Product Change Notification: MFOL-25LIQC654

CCB 8324 and 8324.001 Final Notice: Implement additional plastic tube supplier for selected HC301x, HC123x, HC121x, APT40x, APT60x, APT75x, APT15x, APT30x, APT80x, APT35x, APT25x, APT20x, APT77x, APT53x, APT12x, APT10x, APT50x, APT37x, APT13x, APT34x, APT14x, APT4Fx, APT22x, APT7Fx, APT42x, APT17x, APT7Mx, APT24x, APT9Mx, APT18x, MSC01x, MSC05x, MSC18x, MSC03x, MSC02x, MSC08x, MSC75x, MSC06x, MSC36x, MSC04x, MSC09x device families available in TO-268 package.

PCN Status: Final Notification

CCB#: 8324 and 8324.001
Pre and Post Change Summary
PCN #: MFOL-25LIQC654

Plastic Tube

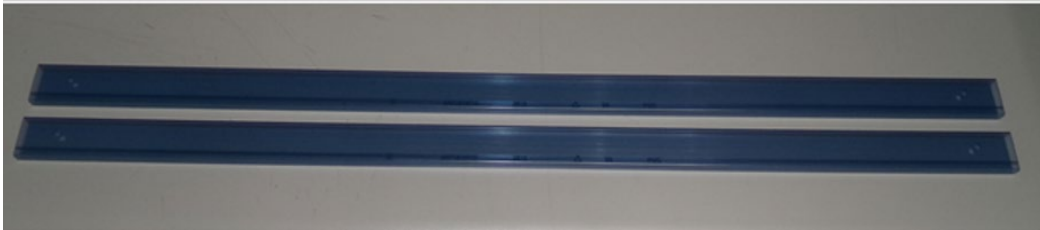
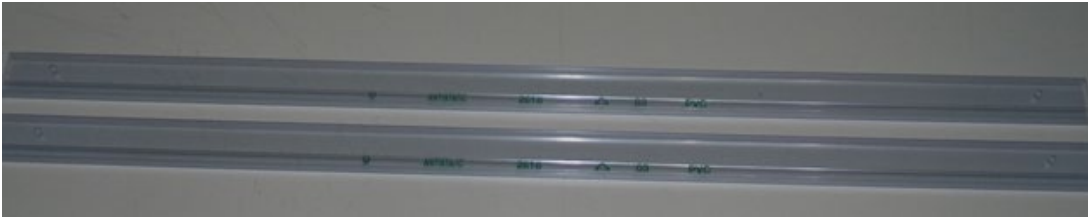
ITW Meritex	Yosiko Industries, Inc.

<table><tr><td>Color</td><td>Blue</td></tr><tr><td>Material</td><td>PVC with Antistatic Coating</td></tr><tr><td>Temp Condition to Avoid</td><td>>200°C</td></tr></table>	Color	Blue	Material	PVC with Antistatic Coating	Temp Condition to Avoid	>200°C	<table><tr><td>Color</td><td>Light Blue</td></tr><tr><td>Material</td><td>PVC with Antistatic Coating</td></tr><tr><td>Temp Condition to Avoid</td><td>>39°C</td></tr></table>	Color	Light Blue	Material	PVC with Antistatic Coating	Temp Condition to Avoid	>39°C
Color	Blue												
Material	PVC with Antistatic Coating												
Temp Condition to Avoid	>200°C												
Color	Light Blue												
Material	PVC with Antistatic Coating												
Temp Condition to Avoid	>39°C
